To: Frank Davila, Director Planning and Zoning

From: Diana Davis, Town Council

RE: Review of Site Plan submitted by landowner Juno Square LLP jointly with Pulte Homes, LLC for Townhouses on Christmas Tree lot adjoining the Juno Square Plaza commercial property

THE DUNES AT JUNO BEACH
 Juno Beach, Florida

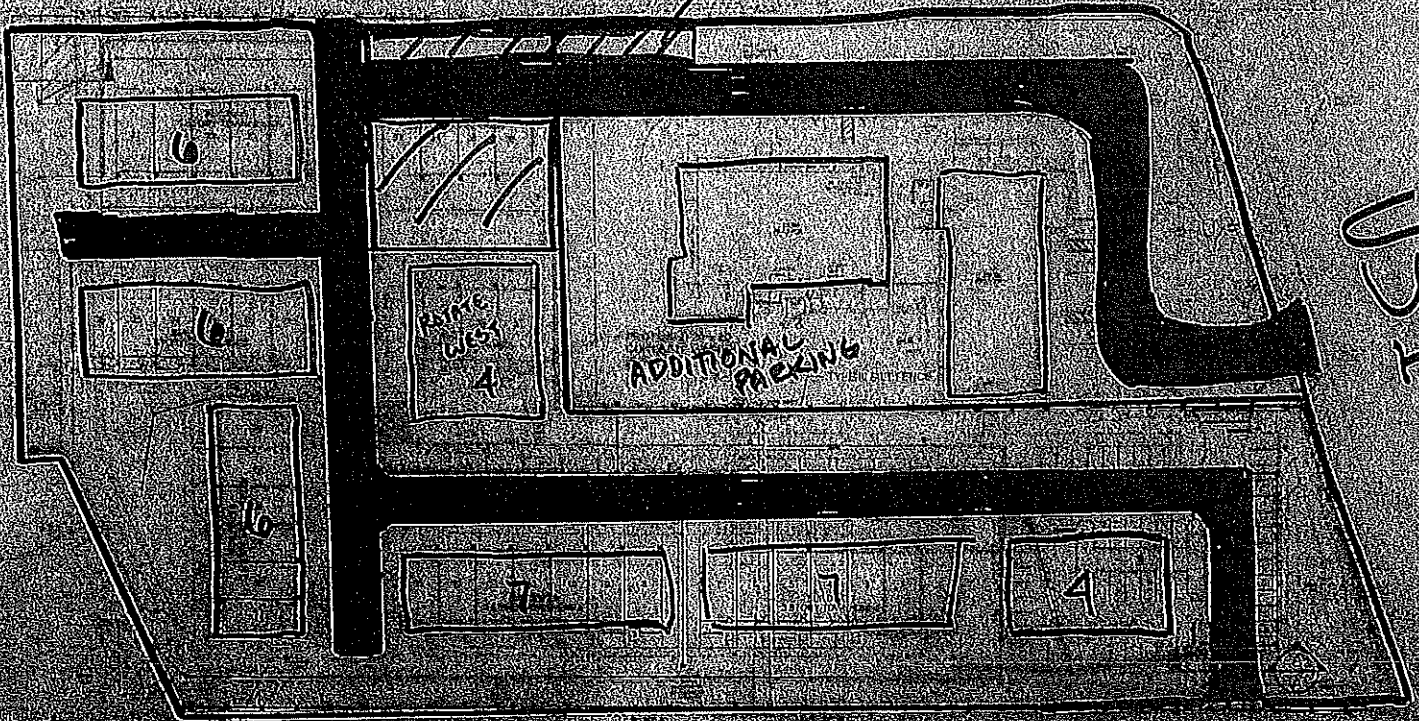
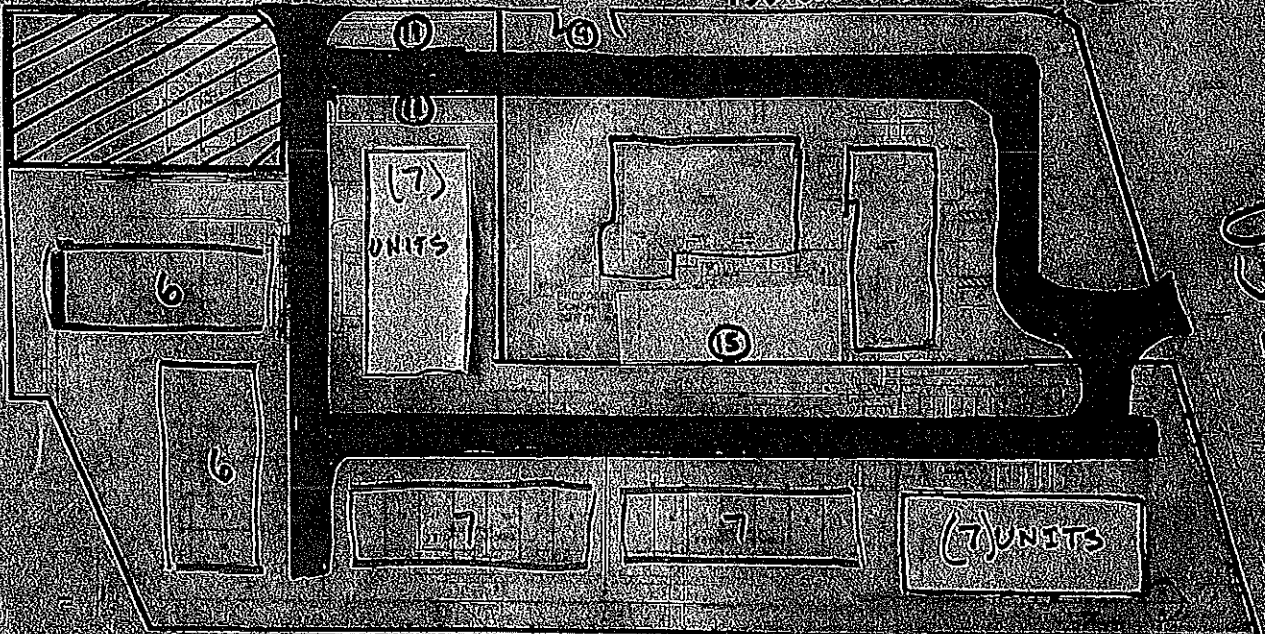
1. Consider alternative site plan layouts as provided in drawings by a Juno Beach resident, who has 30-year experience in commercial development, provided to generate creative ideas that could optimize traffic circulation and improve traffic flow onto Donald Ross Road and U.S. 1. *See, ATTACHMENTS*

6. Right of Way Abandonment - Proposal for value for right of way abandonment and public benefits – suggest a land donation to the Town for property that adjoins the Donald Ross Road. See, resident proposal for a redesigned site plan that considers a land donation and a shared agreement for use of additional parking with the Town.

⊗ - ONLY 2 ACCESS POINTS
 * ADD ADDITIONAL ACCESS POINTS

- PLAN BENEFITS
- ① BEST TRAFFIC PLAN
 - ② ADDING TOWN AMENITY AT NO COST
 - ③ NO TRAFFIC ON FLORAL DRIVE - POLITICAL WIN!

* FLORAL DRIVE ADD POLITE ACCESS

RIGHT TURN IN AND OUT

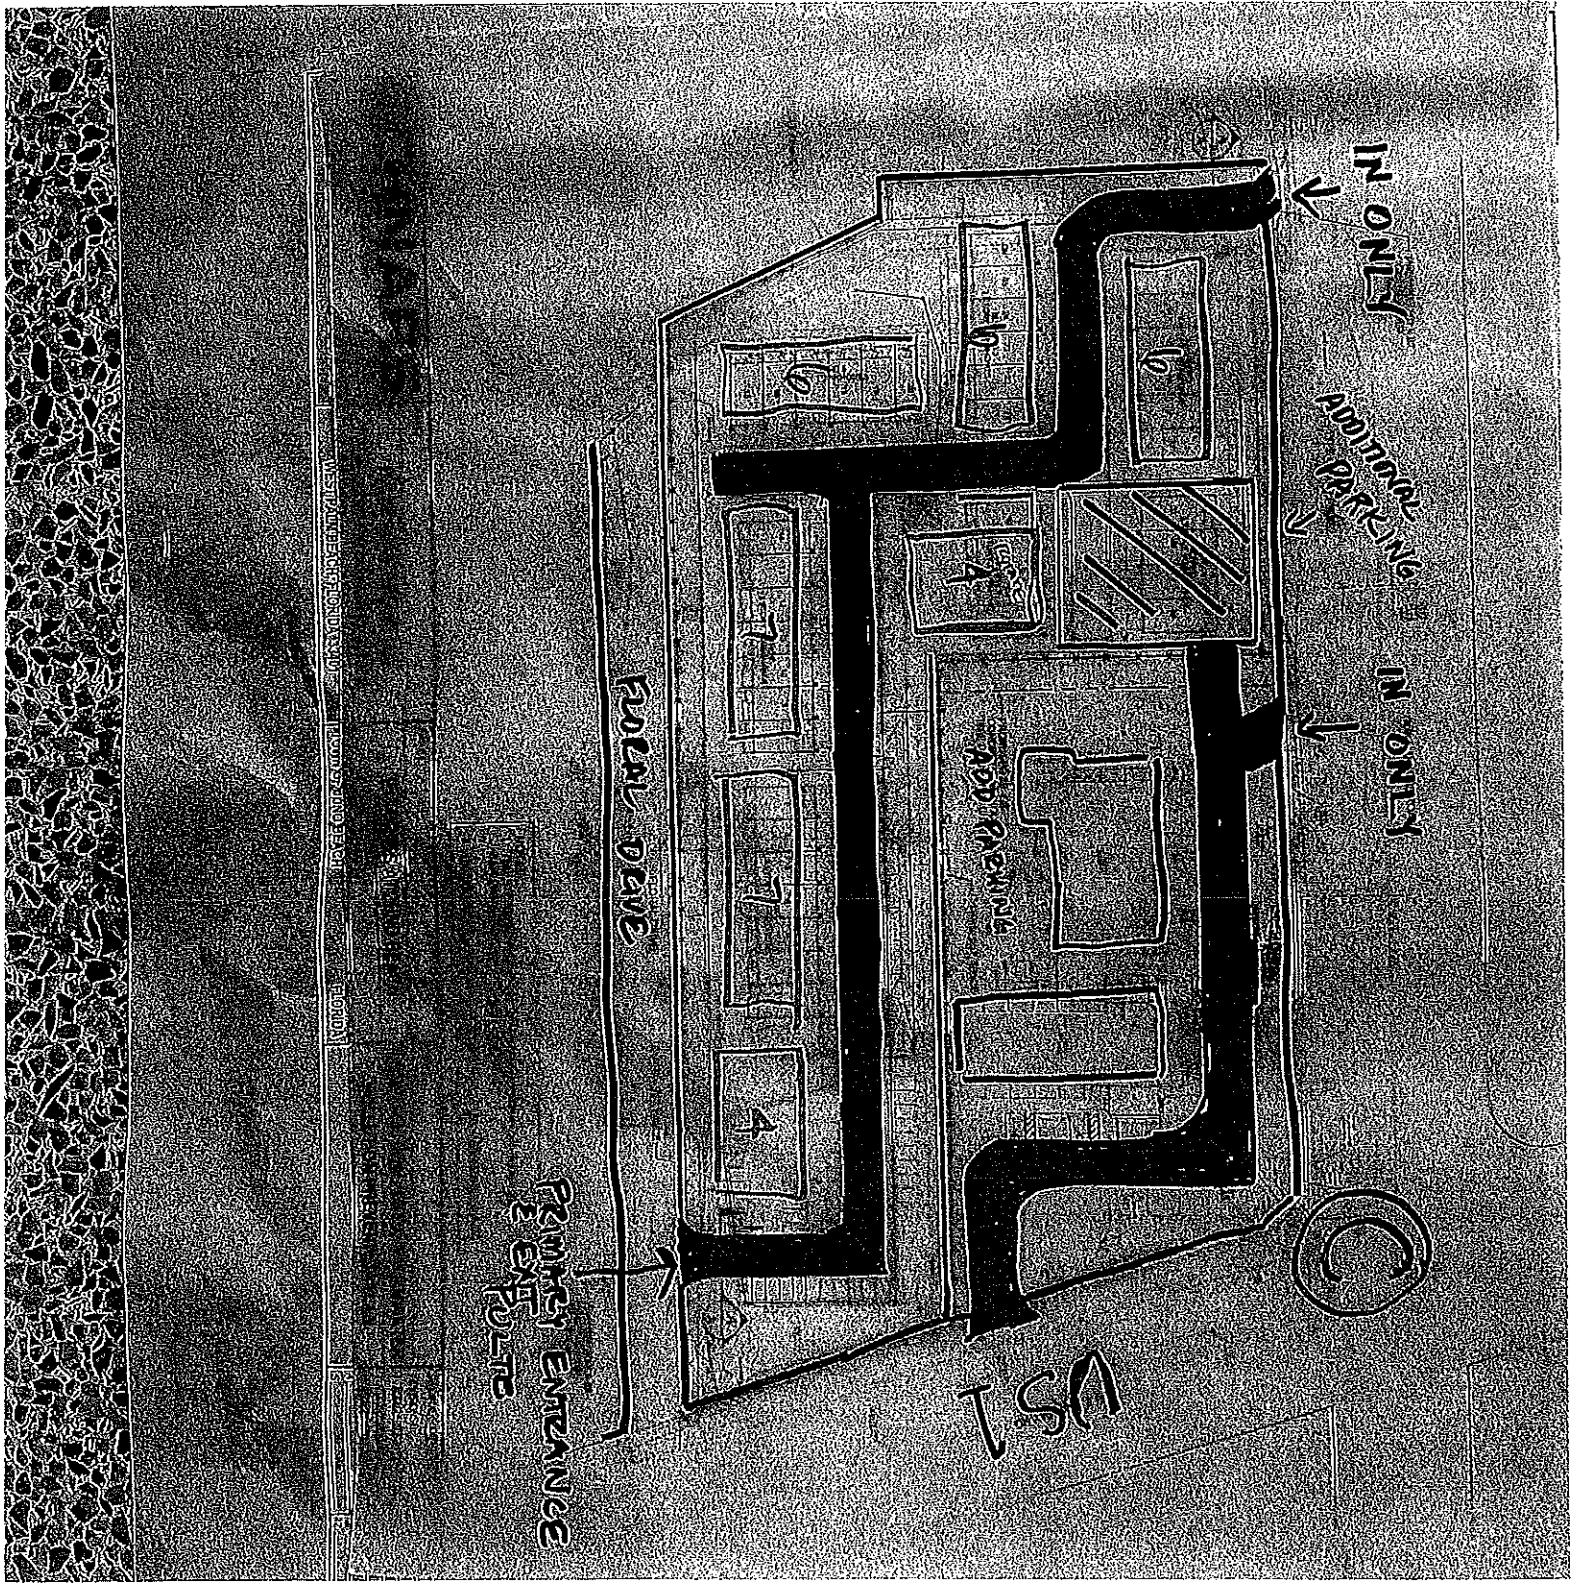
RIGHT IN + RIGHT OUT
RELOCATE
THIRTY TUBES
CURB OUT
155' WEST ±
